## '94 Integra: No Inner Brake Pad Shims

## ACURA ServiceNews

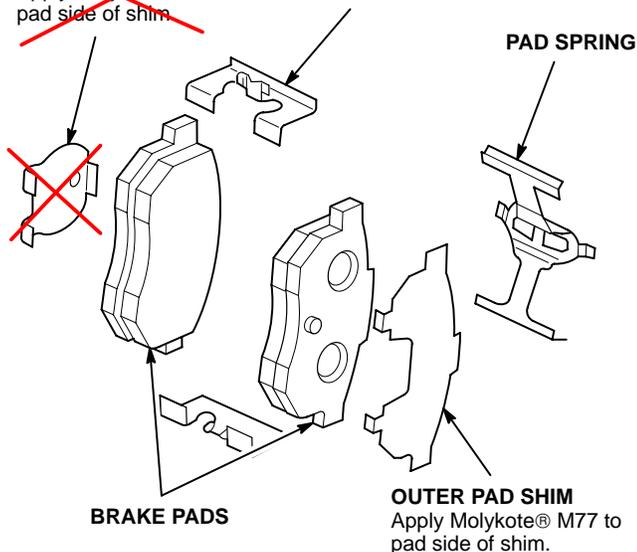
The rear inner brake pad shim shown on page 19-23 of the '94 Integra S/M shouldn't be there. Cross it out; the car doesn't use an inner shim. The '95 Integra S/M has been corrected.

### ~~INNER PAD SHIM~~

~~Apply Molykote® M77 to pad side of shim.~~
